# Specification Update

## PXA3xx (88AP3xx) Processor Family

**Figure 1: Single OS Timer Match Event with an OSSR Write failure window**

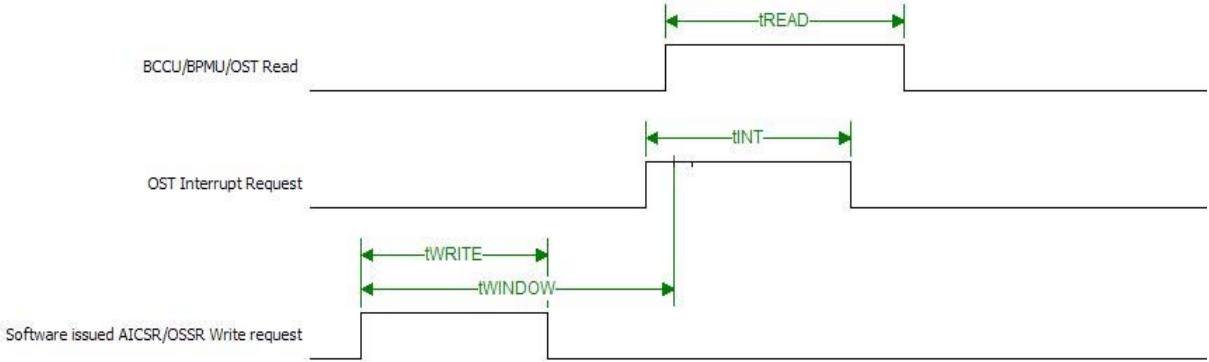
1. Intel XScale® core writes to the OS Timer Status Register (OSSR) or Application Subsystem Interrupt Control/Status Register (AICSR) registers
2. OST Match Event occurs and the OSSR register is written to clear the status bit(s) for the corresponding timer while the OS Timer Interrupt is enabled (OS Timer Interrupt Enable Register (OIER)).
3. The ACCU writes to the AICSR register in response to a Frequency Change (FCIS), Power Mode Change (PCIS) or a Temperature Induced Frequency Change (TCIS) while the interrupts are enabled (FCIE, PCIE and TCIE)

**Implication:** Data corruption will result in system hangs when the two overlapping writes and the register read occur within the following timing windows. [Figure 1](#) and [Figure 2](#) a diagram showing the series of events that

1. The following steps are recommended when using an OS Timer where the counter continues to run after a match event or the counter register is not reset after a match event occurs ( $OSMRx[R] = 0$ )
  - The ACCU frequency change interrupts ( $AICSR[xCIE]$ ) must be disabled and XScale core writes to the AICSR register to clear status bits are prohibited
  - Software must ensure that the XScale core writes to the OSSR register cannot overlap with the OST match event interrupt request.
    - Only write the OSSR to clear the Interrupt Status bit in the OST Match Event Interrupt Service routine.
  - Software must ensure the next Match Event interrupt request is at least 350ns from the previous event.
    - Reloading the OSMRx Register for the next Match event based off the current Match register value ( $OSCR0$ ) is recommended.

2. When using a single OS Timer 4 – 11, the following procedures are recommended to ensure that no overlapping APMU events occur from any source when the Periodic Timer stops incrementing after a match is detected ( $OSMRx[P] = 0$ ) or when the OSCRx register is reset after a match occurs ( $OSMRx[R] = 1$ ).
  - The ACCU Frequency Change interrupts ( $AICSR[xCIE]$ ) must be disabled and XScale core Writes to the AICSR register to clear status bits are prohibited.
  - Software must ensure that XScale core Writes to the OSSR register cannot overlap with the OST Match events.
    - Only write the OSSR to clear the Interrupt Status bit in the OST Match Event Interrupt Service Routine.
